northern
beaches
council

DEVELOPMENT DETERMINATION PANEL MEETING

WEDNESDAY 26 JULY 2023

3.1	REV2023/0009 - 9A Amiens Road CLONTARF - Review of Determination of Application DA2022/0663 for Demolition works and construction of a dwelling house including swimming pool	5

Image: Height line to extrapolated (blue line) and non-compliance with the (excavated) existing ground level line at 8.5m height (red line).

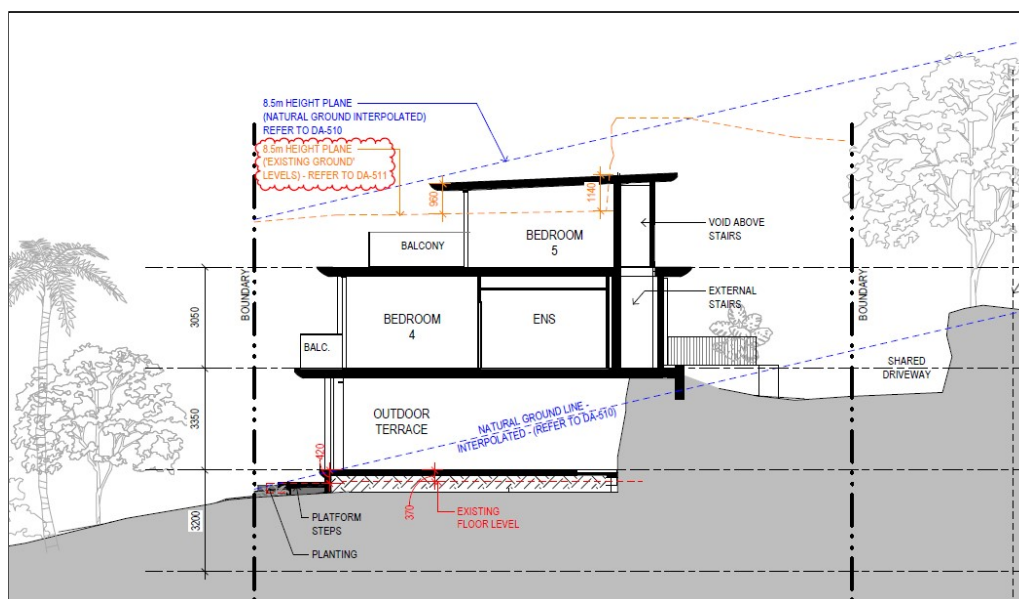
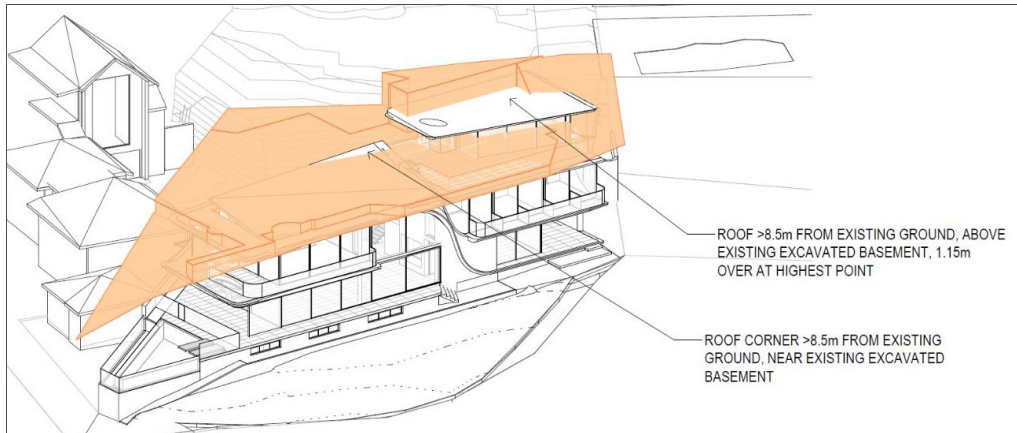
Development standard:	Building Height
Requirement:	8.5m
Proposed:	9.64m
Percentage variation to requirement:	13.4%

The maximum breach occurs at the Level 2 roof area, over Bedroom 5.

Image: Height plane (8.5m) pursuant to existing ground (excavated) ground level. Note that the the roof form over Level 1 at the lower level also marginally extends beyond the 8.5m height plane, with a maximum height of approximately 8.75m, representing a variation of 0.25m or 3%.

Figure 2: Extract of Section A.3
Source: Squillace

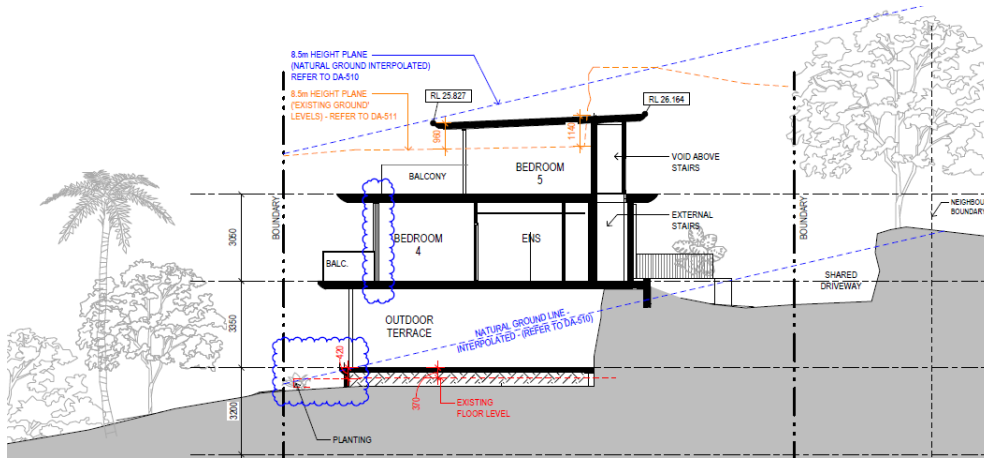
The maximum breach occurs at the Level 2 roof over Bedroom 5, where the proposed development reaches a maximum height of 9.64m above existing ground level, measured from existing excavated areas below the existing dwelling house. The extent of the breach, as shown in Figure 2 is 1.14m or 13.4% of the building height development standard.

Figure 3: Extract of Section A.1
Source: Squillace

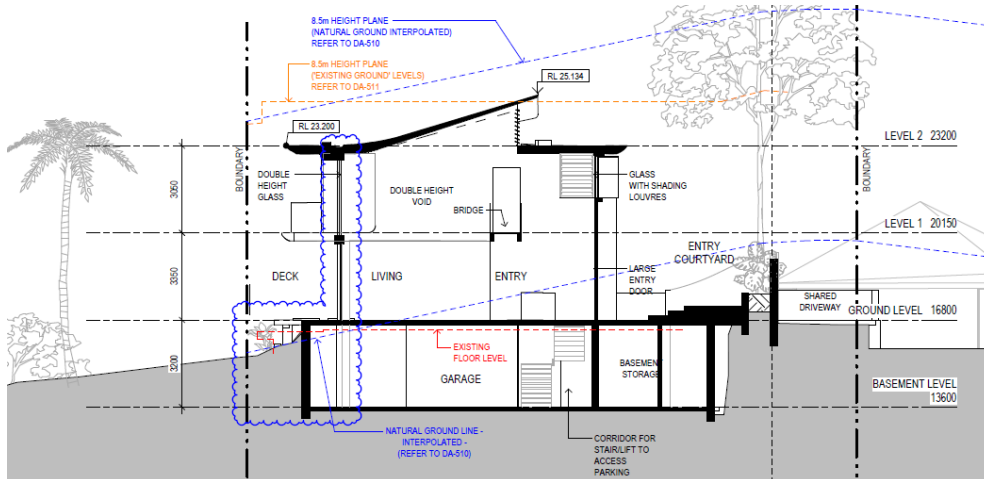
The roof form over Level 1 also marginally extends beyond the 8.5m height plane, with a maximum height of approximately 8.75m, representing a variation of 0.25m or 3%, as shown in Figure 3.

Figure 1 - Plan extract showing non-compliant basement floor space associated with the proposed visitor car space and immediately adjacent circulation.

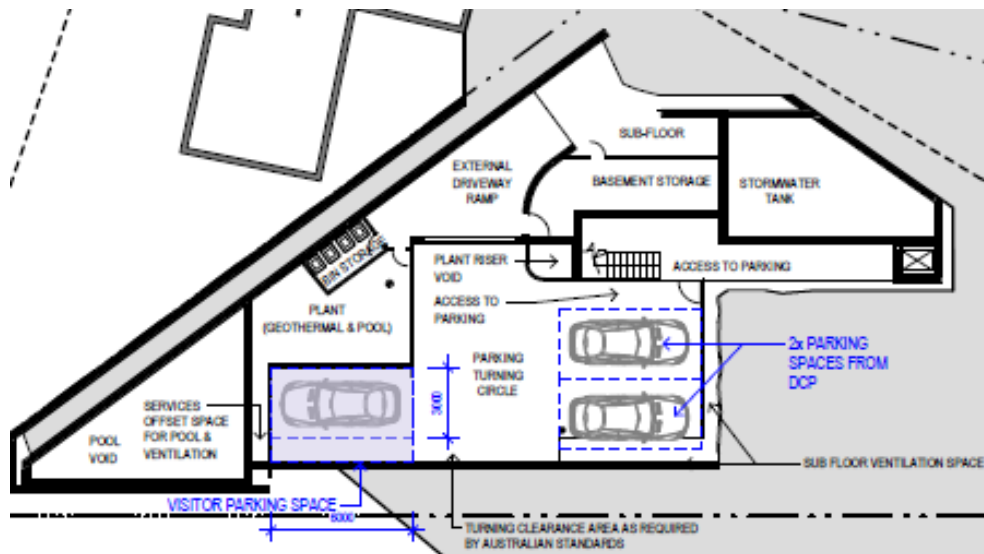
The non-compliant floor space is generally limited to the area of the visitor car parking space and immediately adjacent circulation located within the basement of the development as depicted in Figure 1.

Image: Height of the dwelling house roof apex is being reduced overall from RL27.66 to RL27.36 due to lower roof profile however the maximum height is actually attributed to the north-eastern wall (facing the foreshore).

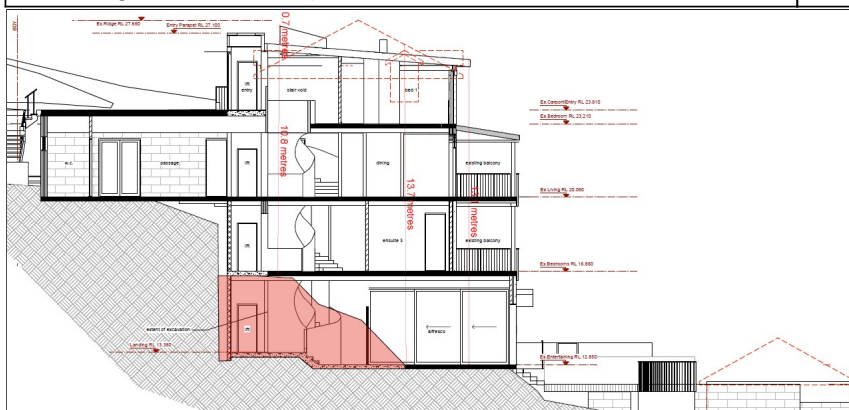
Description of Non-compliance:	
Development standard:	Building Height
Requirement:	8.5m
Proposed:	13.1m
Percentage variation to requirement:	54.1%

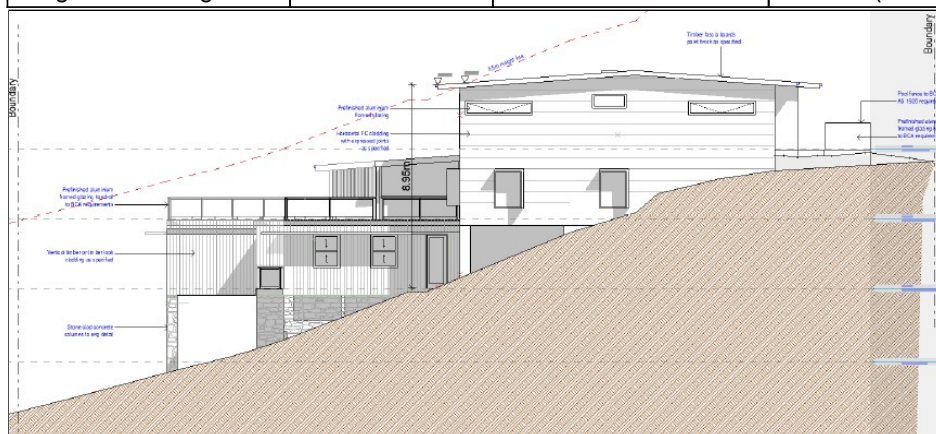
Standard	Requirement	Proposed	% Variation	Complies
Height of Buildings	8.5m	Roof eaves :8.95m	5.29% (0.45m)	No

Height measured from existing ground level. The land currently has no significant excavation along the existing ground line at the high point.

Image: Height plane variation for renewed building elements and new elements.

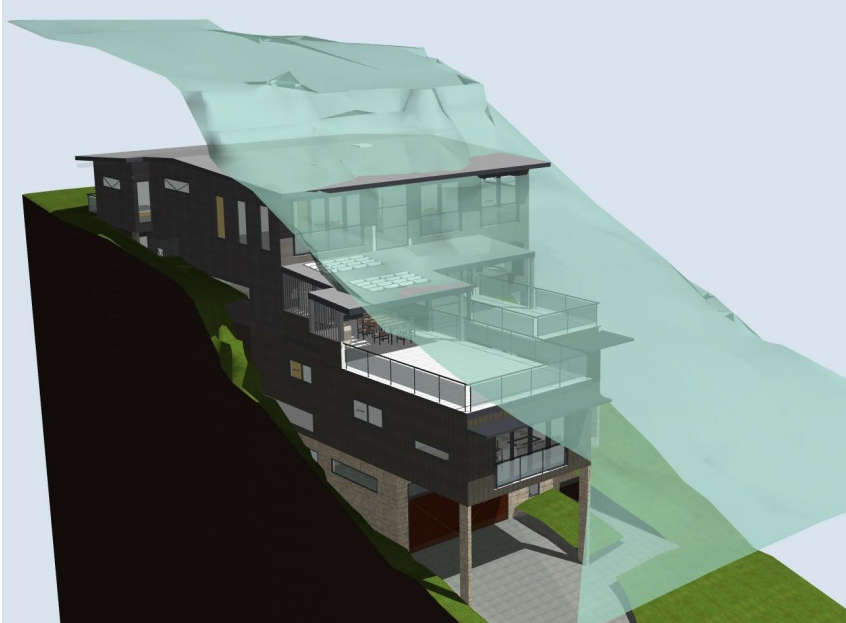
The diagram below shows the non-compliance in association with existing ground level along the forward roof edge (upper storey) and corner of upper wall above the 8.5m height plane.

Figure 1 - Maximum Building Height Non-compliance

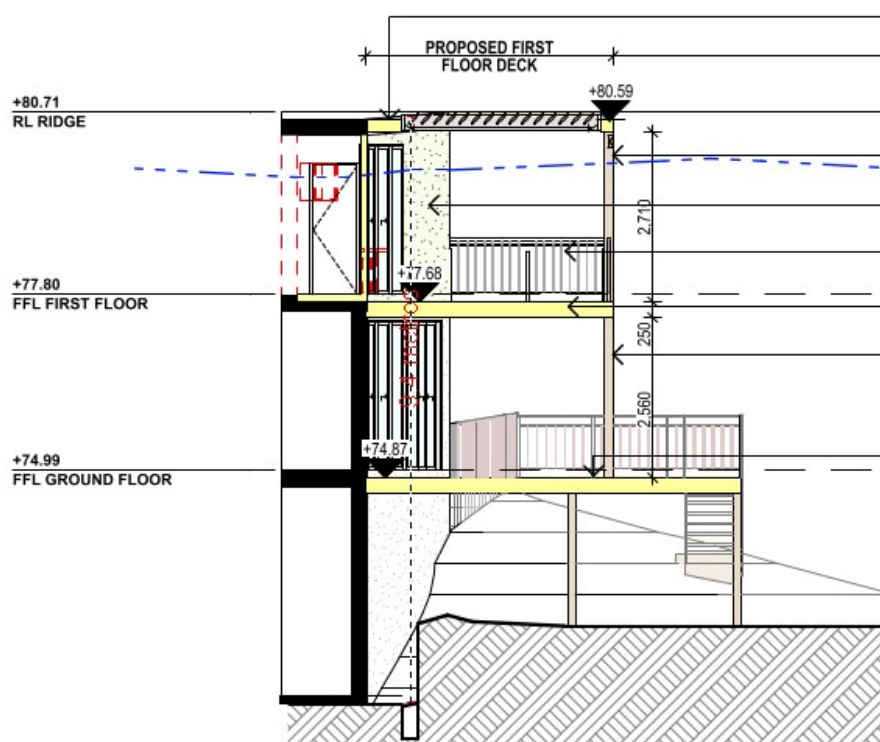
Development standard:	Height of buildings
Requirement:	8.5 metres
Proposed:	9.4 metres
Percentage variation to requirement:	10.6%

Figure 25 - Battle-axe Allotments

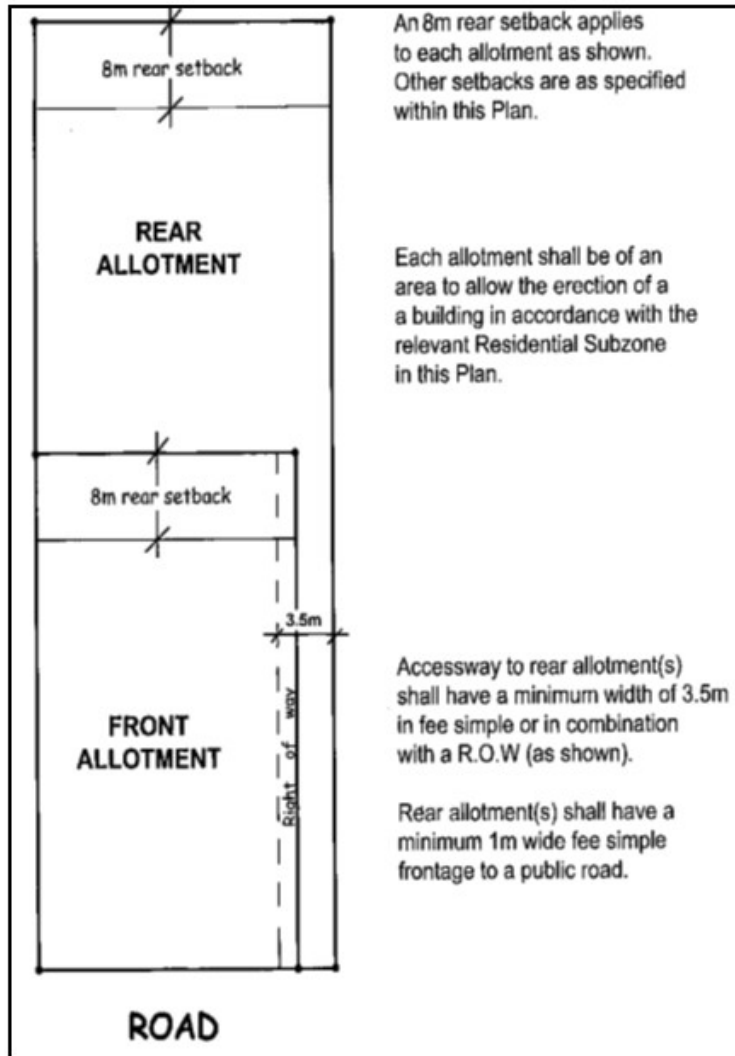
The subdivision layout is not consistent with the above figure and does not provide the 1m wide fee simple frontage to a public road.

Figure 1. East Elevation (red highlighting building envelope numerical non-compliance)

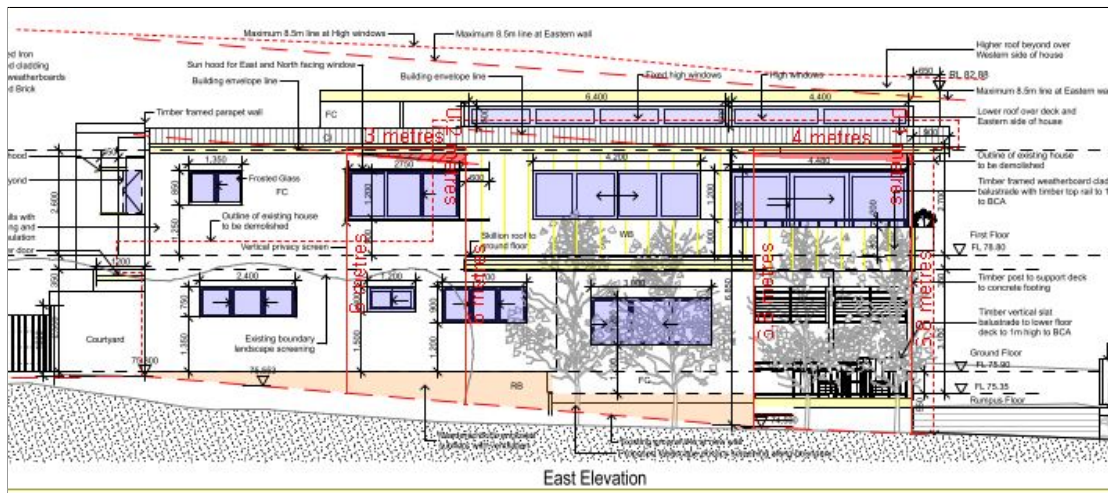
The proposal sits outside of the building envelope on the East Elevation as depicted in Figure 1, and the West Elevation as depicted Figure 2. The East Elevation presents two encroachments, with the maximum encroachment being 0.2 metres in vertical height for a horizontal length of 4 metres, resulting in a maximum variation of 3.33% (0.2m). It is noted that the breach in building envelope at these points are attributed to the sloping topography of the site.

Figure 2. West Elevation (red highlighting building envelope numerical non-compliance)

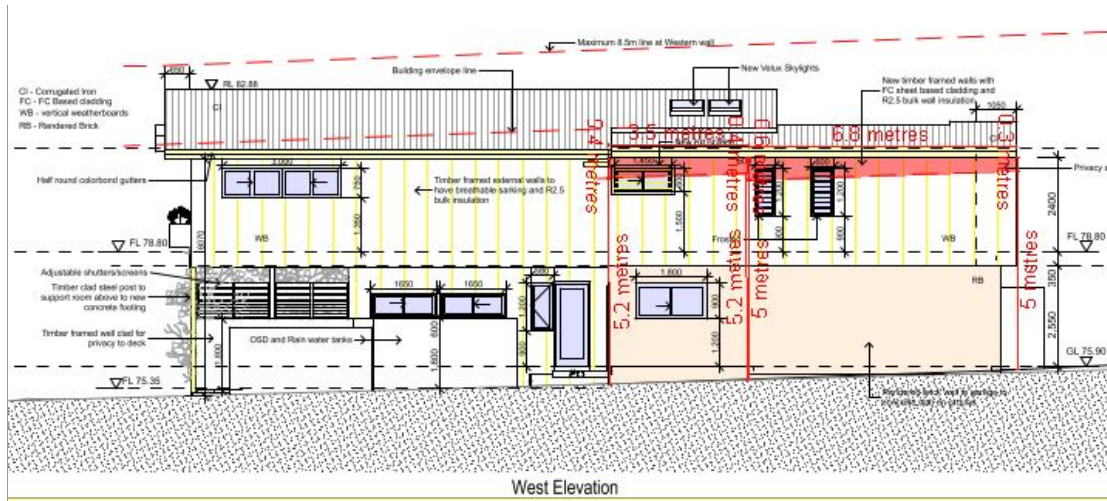
The West Elevation presents two encroachments, with the maximum encroachment being 0.6 metres in vertical height for a horizontal length of 6.8 metres, resulting in a maximum variation of 12.0% (0.6m).

Figure 1. South Elevation (red oval showing height of building non-compliance)

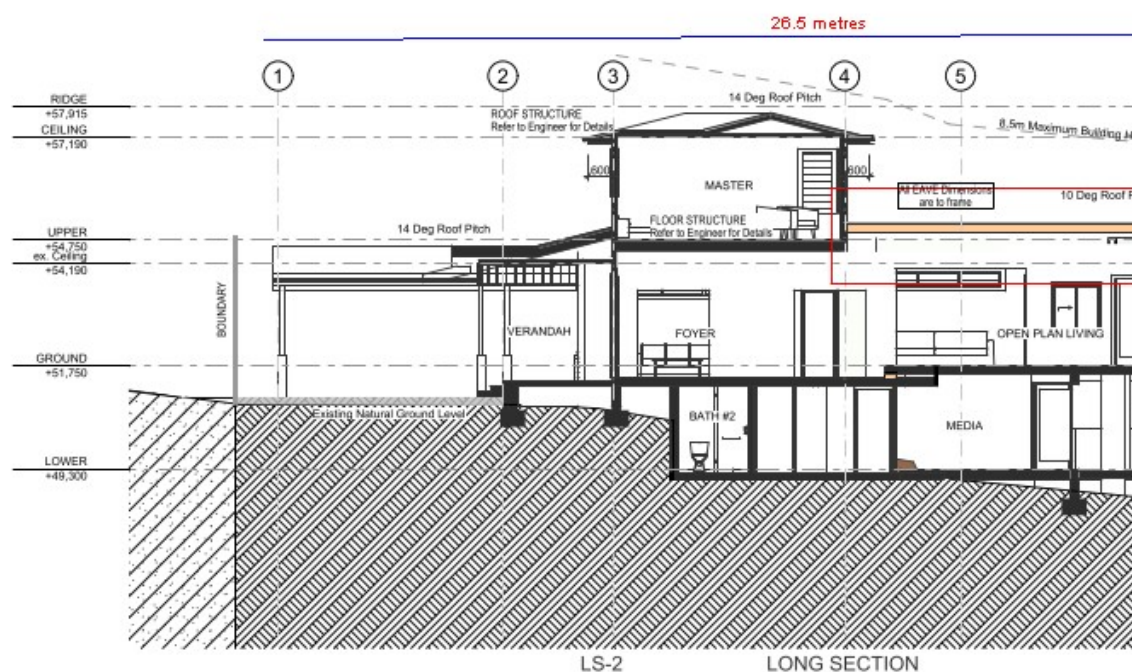
The proposed variations to the height of buildings development standard are detailed in Figure 1 below:

Fig 1: Extract from revised plans noting the area of the proposed building height non-compliance

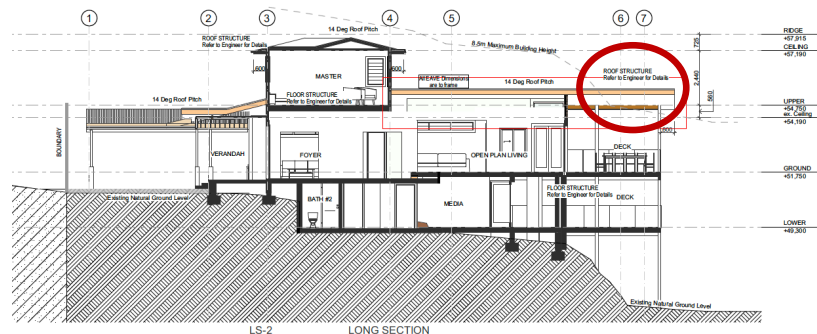
The proposed modifications to the approved dwelling additions will result in an amendment to the rear roof form with a maximum height of up to 9.781m in height, resulting in a non-compliance of 1.281m or 15% to the control, as noted in Figure 1.
